## Agenda Item # 10

SUB-002854-2024 & SUB-SW-002853-2024

Fireside of Mobile Subdivision

- Subdivision approval to create two (2) legal lots of record.
- Waive construction of a sidewalk along West I-65 Service Road South.

## SITE PLAN

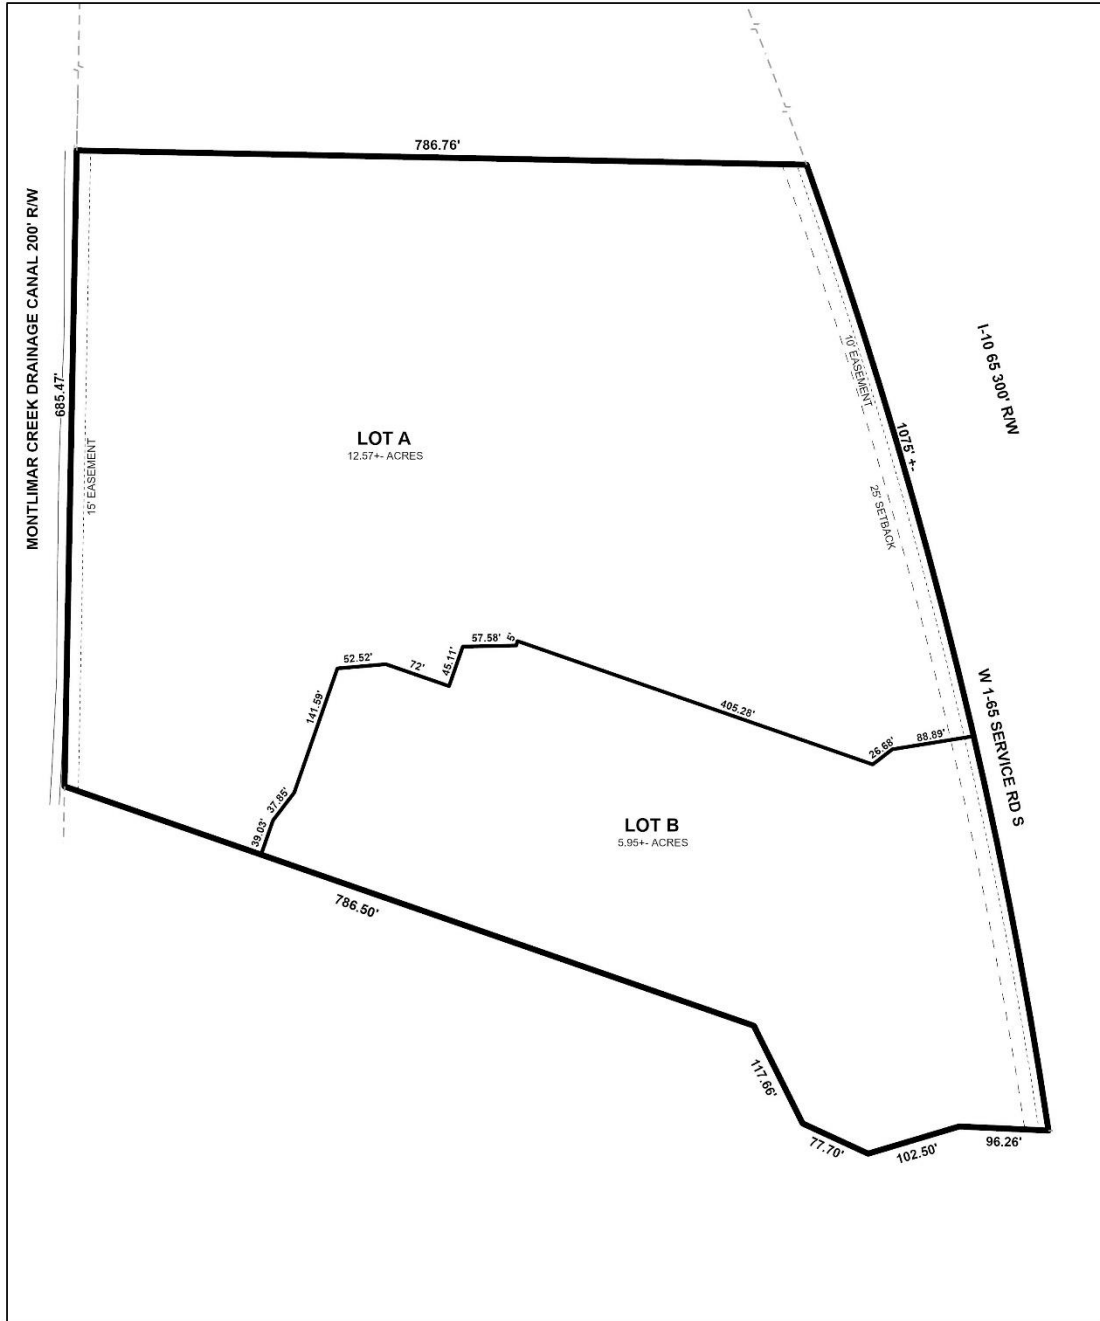
- B. National Wetlands Inventory (NWI) mapping, as shown on City of Mobile GIS information, indicates that there is potential for wetlands within the property or properties shown on this plat. Show and label the delineated wetlands, or provide a note stating that the wetlands shown on this plat are scaled from the NWI data and have not been delineated.

- C. Provide a note that a 25' riparian buffer may be required, during development, along the edge of anything considered by ADEM to be a water of the state.

- D. Label the 10' DRAINAGE AND UTILITY EASEMENT along the east property line as "10' DRAINAGE (PRIVATE) AND UTILITY EASEMENT".
- E. Revise NOTE # 7 to read "As shown on the 1984 aerial photo (FLIGHT 24 - #82) LOTS A and B will receive historical credit of existing (1984) impervious area towards stormwater detention requirement per Mobile City Code, Chapter 17, Storm Water Management and Flood Control) as follows: LOT 1 – NONE AND LOT 2 – NONE.

The proposed lots have frontage on West I-65 Service Road North, an ALDOT-maintained street that services Interstate 65 and requires a 300-foot right-of-way. A varying right-of-way is depicted along West I-65 Service Road North at this location, with a note indicating the minimum right-of-way is 300 feet; therefore, this note should be retained on the Final Plat, if approved.

Proposed Lot A abuts the Montlimar Creek Drainage Canal, to the West, which is depicted with a 200-foot right-of-way and is consistent with the previously approved subdivision of the site. As such, if approved, this information should be retained on the Final Plat.

Both lots, as proposed, exceed the minimum size requirement for lots served by public water and sanitary sewer in a B-3 Suburban district, and are appropriately labeled in square feet and acres. If approved, this information should be retained on the Final Plat; or, provision of a table on the Final Plat with the same information will suffice.

The 25-foot minimum front yard setback is illustrated along West I-65 Service Road South, in compliance with Article 2, Section 64-2-14.E. of the Unified Development Code for lots zoned B-3.

A 10-foot drainage easement is depicted along West I-65 Service Road North, and a 15-foot sanitary sewer easement is depicted along Montlimar Creek Drainage Canal, to the West. A note on the preliminary plat states no structures shall be constructed in any easement without permission of the easement holder, and should be retained on the Final Plat, if approved.

establishing such access. As such, if approved, revision of the plat should be required to depict the appropriate easement that facilitates cross access between the two (2) properties; or provision of a legal document providing the same information and recorded in Mobile County Probate Court may instead be accepted, prior to signing of the Final Plat.

1. Retention of the right-of-way width(s) as depicted on the preliminary plat;
2. Retention of the lot sizes in both square feet and acres, or the provision of a table on the Final Plat with the same information;

3. Retention of the 25-foot front yard setback along West I-65 Service Road South;
4. Retention of a note on the Final Plat stating no structures shall be constructed in any easement without permission of the easement holder;

5. Revision of the Final Plat to illustrate a cross-access easement, or provision of a recorded legal document with the same information, prior to signing of the Final Plat;
